**FINAL DRAINAGE REPORT  
FOR  
ESTATES AT CATHEDRAL PINES  
EARLY GRADING,  
EL PASO COUNTY, COLORADO  
PCD File No. EGP232**

November 2023

Job No. 25260.00

PROPOSED DRAINAGE MAP  
CATHEDRAL PINES--EARLY GRADING  
JOB NO. 25260.00  
11/27/23  
SHEET 1 OF 1

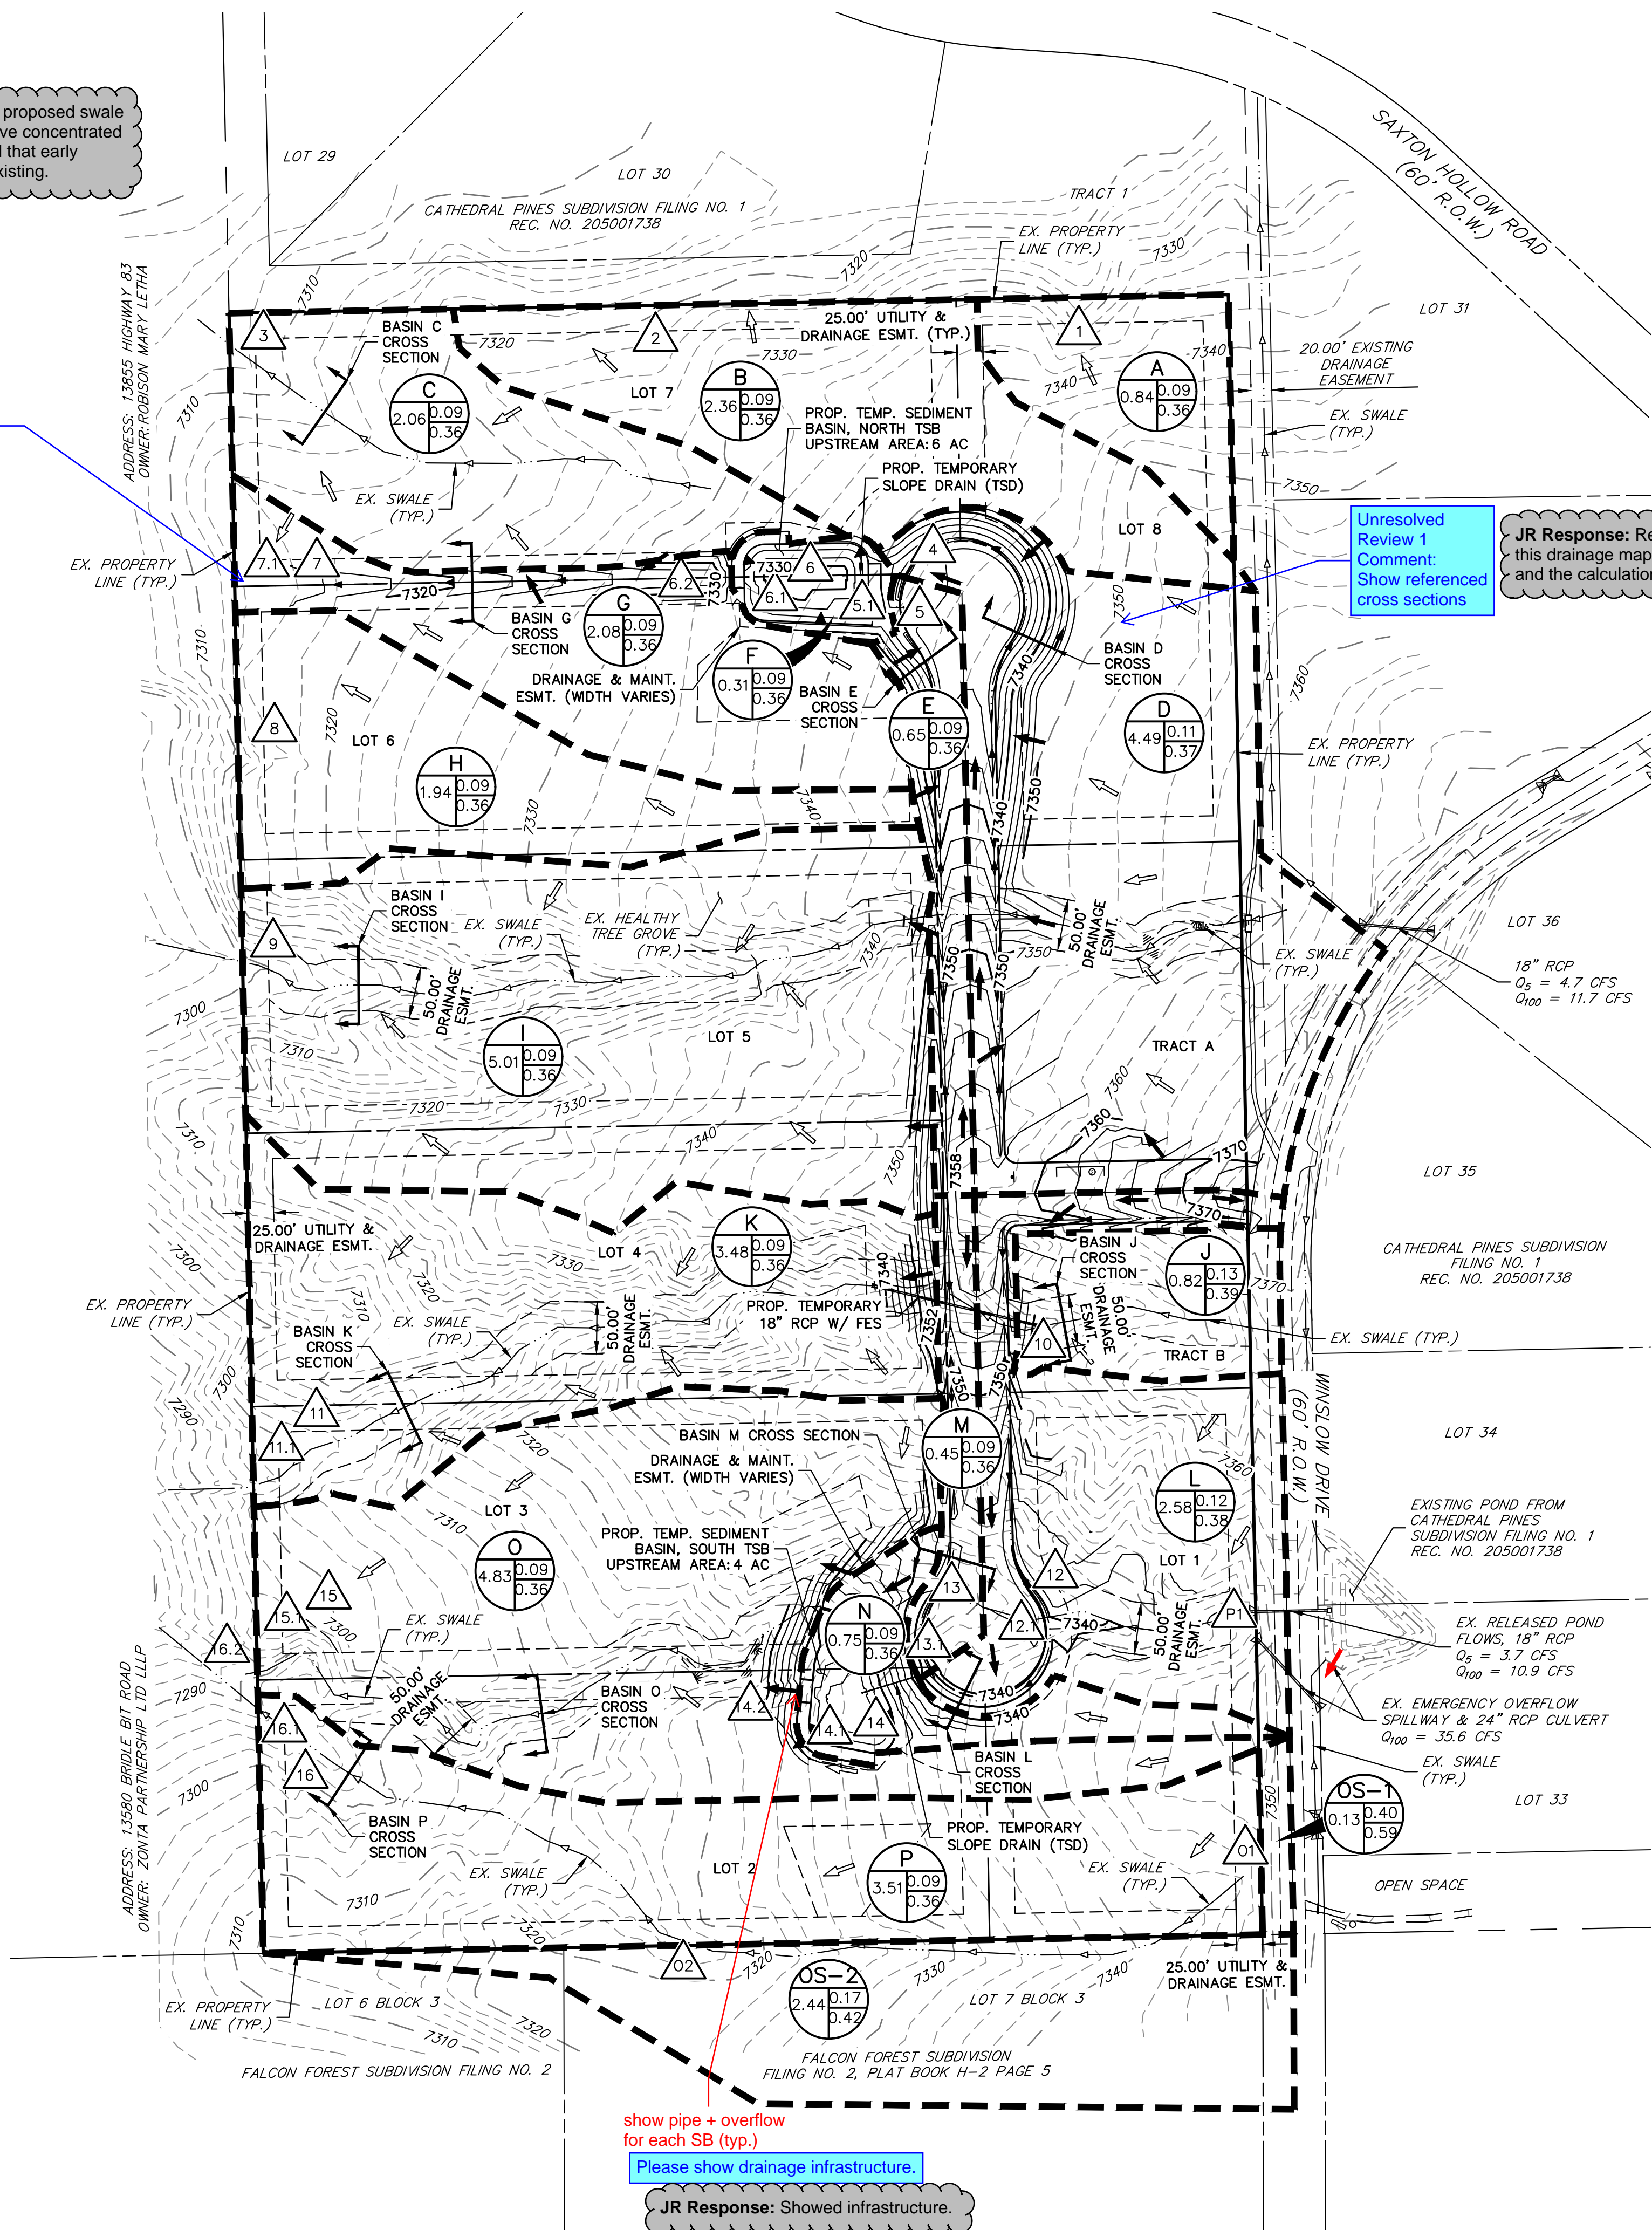
how did we address this comment/concern?

Please address unresolved Review 1 comment.

Concentrated flow is discharged at this location which is a change from historic conditions. Additional analysis downstream is required to the next suitable outfall. See ECM 3.2.4.

Unresolved Review 1 Comment: Show referenced cross sections

Unresolved Review 1 Comment:  
Show referenced cross sections

[Please address unresolved Review 1 comment.](#)

Please address unresolved Review 1 comment.

Please show drainage infrastructure.

Concentrated flow is discharged at this location which is a change from historic conditions. Additional analysis downstream is required to the next suitable outfall. See ECM 3.2.4.

how did we address this  
comment/concern?

how did we address this comment/concern?

show pipe + overflow for each SB (typ.)

**JR Response:** Revised design to have proposed swale route to existing natural swale to not have concentrated flow discharged in new location. Proved that early grading proposed flows are less than existing.

**JR Response:** Refer to the note on this drainage map to see the sections and the calculations.
